## **1.1 Purpose of the Response to Comments Document**

This Response to Comments document responds to comments received on the South Bay Salt Pond (SBSP) Restoration Project Draft Environmental Impact Statement/Report (EIS/R) for Phase 2 at Eden Landing Ecological Reserve (ELER or the Reserve). The Draft EIS/R identified the environmental consequences associated with the implementation of project actions, as well as mitigation measures to reduce significant and potentially significant impacts. As a result of comments received, the Draft EIS/R has been revised. The revised environmental analysis, together with this Response to Comments document and full set of appendices, constitutes the Final Environmental Impact Report (EIR) for the proposed SBSP Restoration Project for Phase 2 at ELER.

On April 6, 2018, the lead agencies for the Draft EIS/R, USFWS and CDFW, released the Draft EIS/R for the SBSP Restoration Project Phase 2 at ELER for public review (State Clearinghouse No. 2016052051). The public review and comment period on the Draft EIS/R began on April 6, 2018 and closed on May 21, 2018 for comments addressed to federal agencies and June 5, 2018 for comments addressed to sta

**X BEACH MODELING**

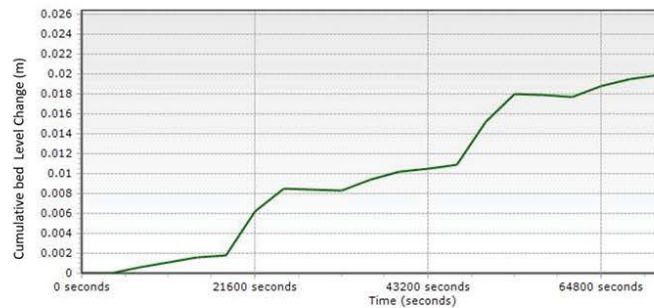
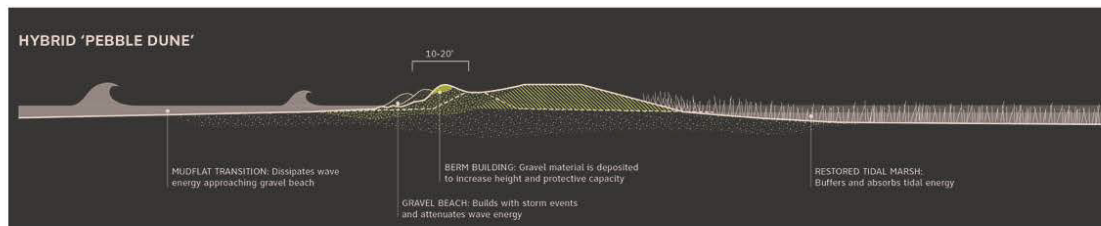
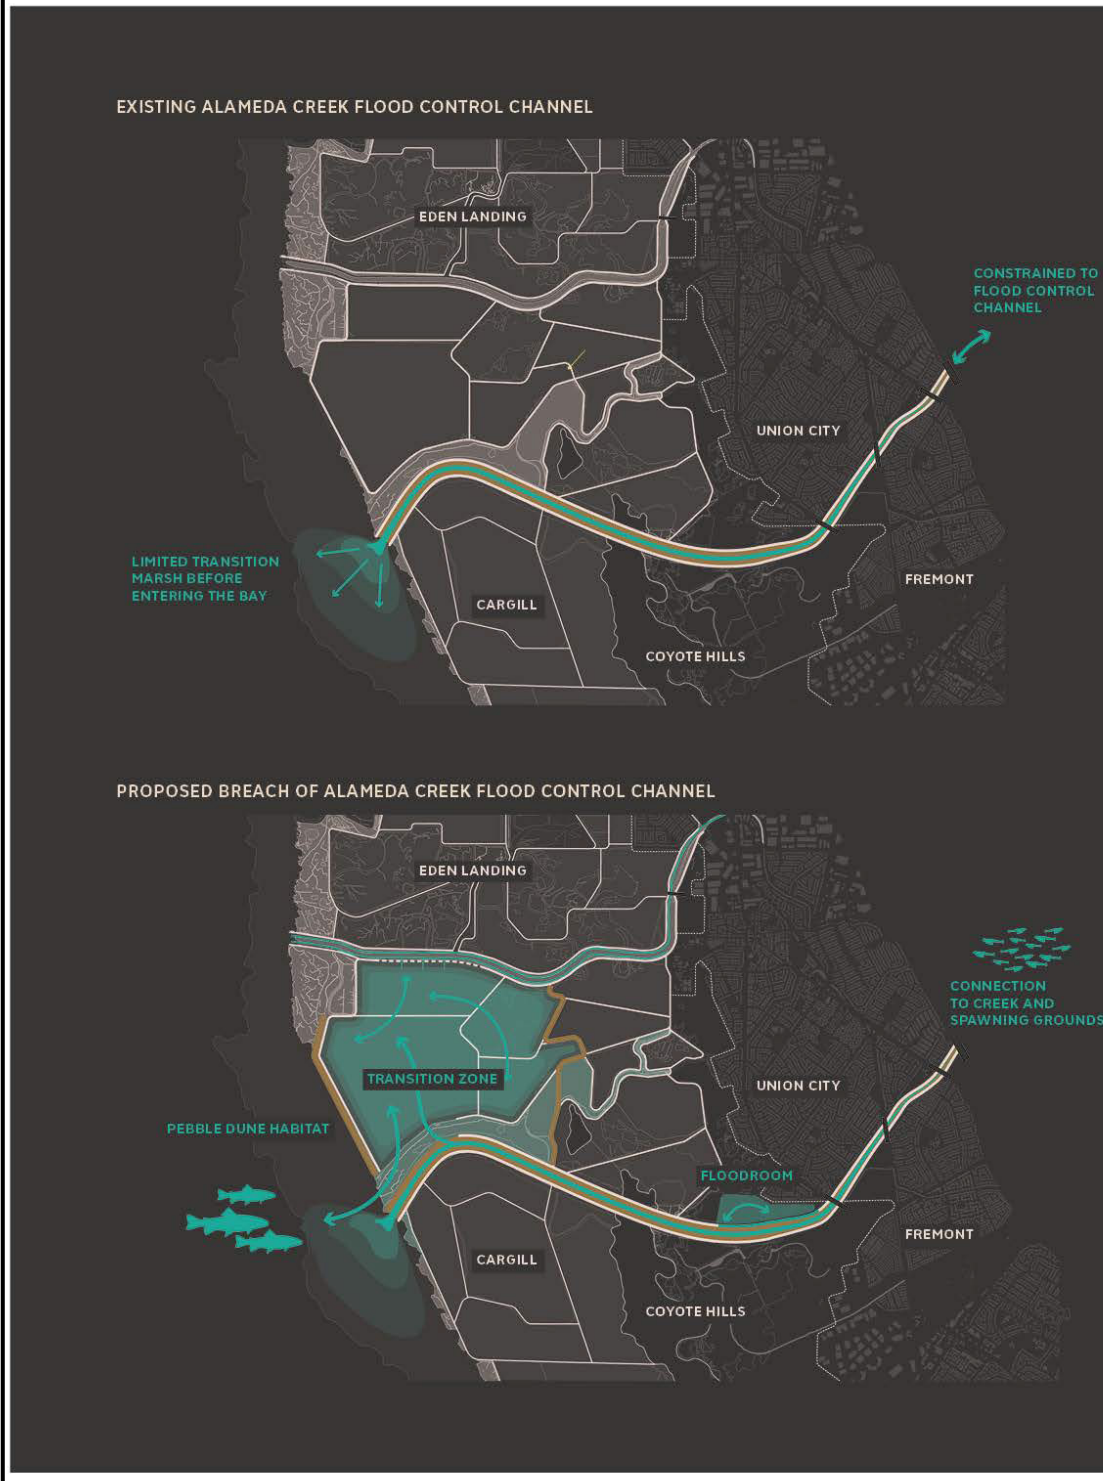
For the pebble dune feature, a preliminary analysis of beach response to storm conditions was conducted. The primary focus of this analysis was to understand the potential response of the pebble dune to storm wave conditions at various water levels. This model is intended to be exploratory of the possible responses a pebble beach face may have to the storm wave conditions in the vicinity of the Eden Landing Wetland Restoration Project.

The Deltares XBeach-G program was utilized to conduct the preliminary analysis based on historic storms within the South Bay. XBeach-G is a 1-dimension model which is similar to the SWASH model that solves wave-by-wave flow and surface elevation variations due to short waves in intermediate and shallow water depths. This is particularly important for application on gravel beaches, where due to steep slopes swash motion is mainly at incident wave frequencies.

Beach response to storm wave conditions were modeled for varying beach slopes and grain sizes (D50). The beach profile, wave conditions and water levels used in the analysis included:

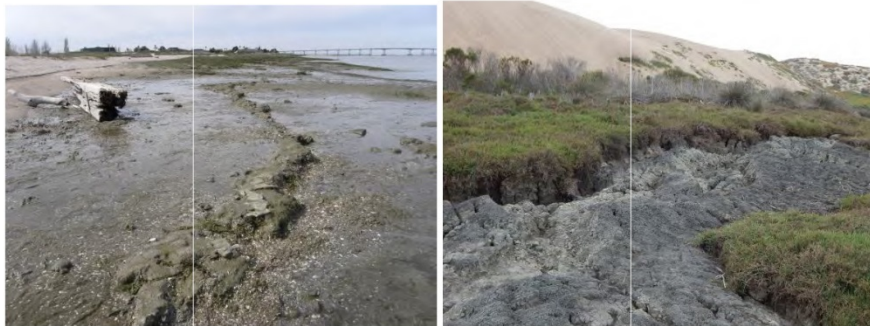
explicitly excluded or rejected from any alternative. Moreover, this design objective is expressly inconsistent with Appendix D, Preliminary Design Report description of the Bay Levee purpose in context of alternatives C and D (p. 21):

The Bay Levee will be raised for habitat enhancement, not flood protection. Hydrodynamic modeling results ...show that tide waters will enter southern Eden Landing through the OAC breaches and lowered levees, and therefore increasing the height of the Bay levee will not reduce the water surface elevation within the Bay and Inland Ponds. Raising this Bay levee may reduce wave overtopping...

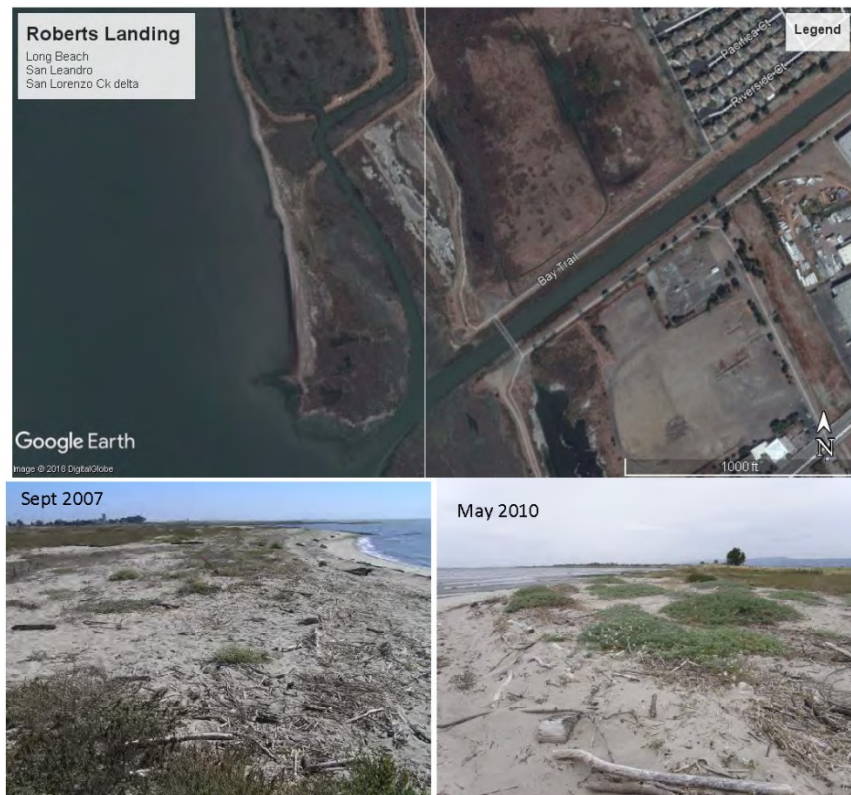
The north sand spit of Radio Beach has provided an attractive roosting habitat for elegant and Caspian terns. Wave action and sand mobility maintain barren substrate attractive to terns and shorebirds.

These and other San Francisco Bay barrier beaches provide reference conditions demonstrating habitat value for terns (roosts at Radio Beach north end spit), western snowy plovers (vagrants at Roberts Landing), and potential suitable habitat for endangered California sea-blite. A USFWS pilot reintroduction project in 2008 included Roberts Landing, but was terminated due to unfortunate timing of extreme storm erosion after transplanting. Barrier beaches, especially those with gravel berms, “self-seal” rather than fail and tidally breach during storm erosion events, as artificial bay levees do. Barrier beaches with sufficient sediment supply retreat landward while building vertically (foredune accretion) and retaining geomorphic integrity (profile migration landward by “barrier rollover” – dune and washover migration), instead of eroding in place and leaving a lag of immobile residual rocky fill (land mass failure legacy). In relation to restoration and flood control objectives, a barrier beach restoration would provide an environmentally superior alternative to an earthen “land mass” of imported upland fill. Beach restoration would provide multiple benefits naturally compatible with the restored tidal marsh platform, and would require less fill. Like Aramburu Island beach, the beach could be designed to “self-construct” by wave and wind action following profile

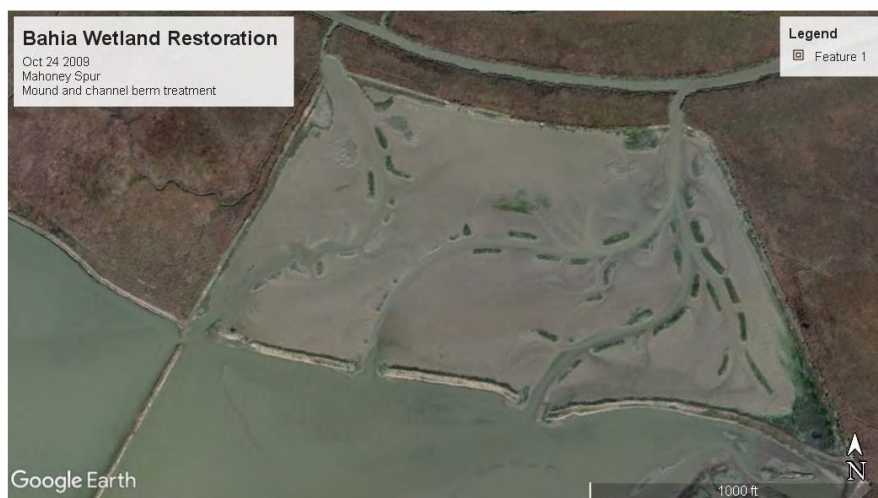
Interior tidal marsh patterning of well-developed high tide emergent vegetation canopy cover is evident during marsh submergence events, concentrated along banks of tidal creeks in upper Newark Slough. Island-like patches of tall pickleweed and gumplant delineate smaller branch tidal creeks far from artificial levee or terrestrial shorelines.

The environmentally superior/preferable alternative should provide the maximum creek-parallel distribution of effective high tide refuge habitat (tall high intertidal marsh vegetation) in restored tidal marsh. Alternatives should not excessively weigh benefits of peripheral HTZs as high tide refuge habitat over internal high tide refuge habitat of the salt marsh plain. An early example of a tidal marsh restoration project that integrated both internal high marsh and landward-edge high tide transition zones as high marsh refuge for California Ridgway's rail and SMHM is the Bahia Wetlands Restoration Project in Novato, Marin County (California Department of Fish and Wildlife and Marin Audubon Society). In this case, broad habitat transition zones (non-irrigated horizontal levees, 10:1-20:1 slopes at the landward edge) and high marsh mounds and berms (aligned along constructed pilot channels) were combined, and developed stabilized high marsh to low salt marsh gradients that spread laterally over adjacent mudflats in the first year after construction. Radial marsh progradation from the mounds occurred much sooner and faster than pioneer colonization of mudflats.

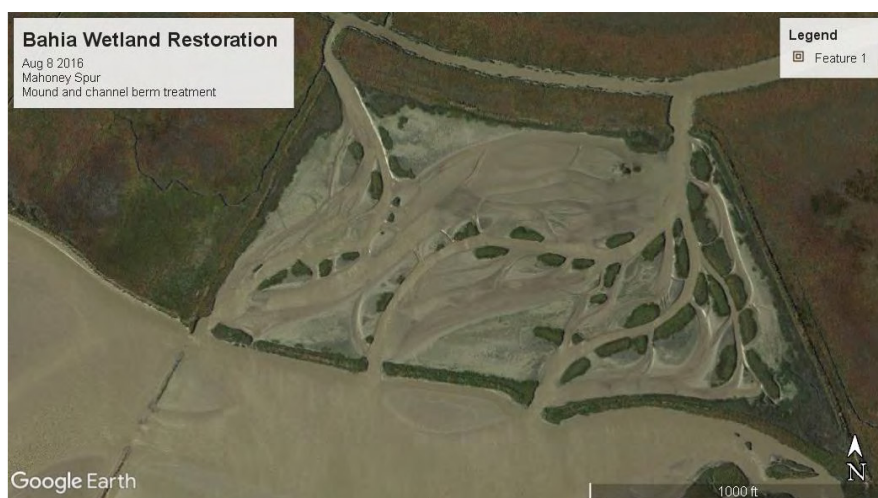
Upper intertidal berms and mounds were constructed along the margins of main pilot tidal channels to provide high tide refuge habitat patterns aligned with tidal channels in the example of the Mahoney Spur cell of Bahia Wetlands Restoration project (Novato, Marin County, California Department of Fish and Wildlife lands) in August 2008. By October 2009 (Google Earth image above), the berms and mounds were naturally colonized by salt marsh vegetation sooner than surrounding mudflats and graded levees. This was one of the first constructed high salt marsh mounds of this type and pattern. It is based on natural tidal creek-pattered distribution of high tide refuge habitat in tall creek bank vegetation.

**A few photos to illustrate points:**

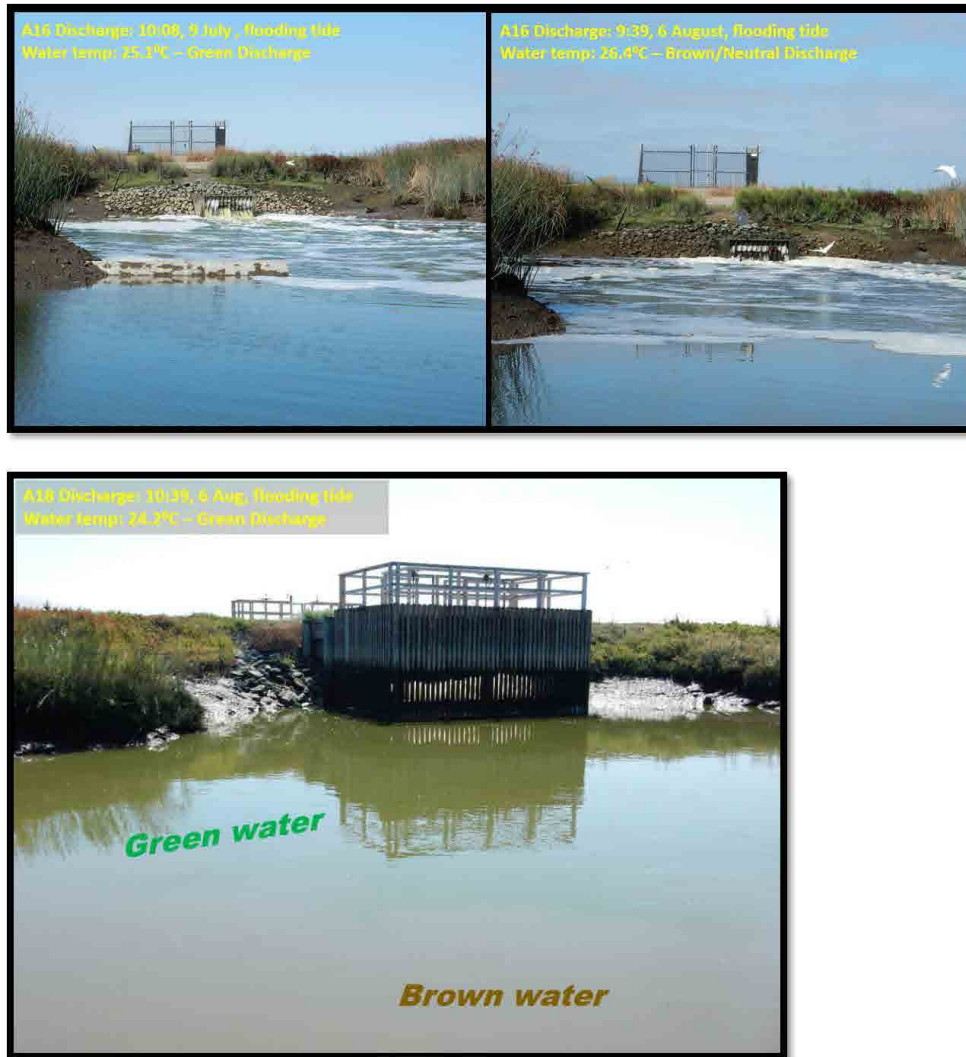
For better or worse, muted and managed ponds tend to produce green water! (no ill effects have been observed – so far!)
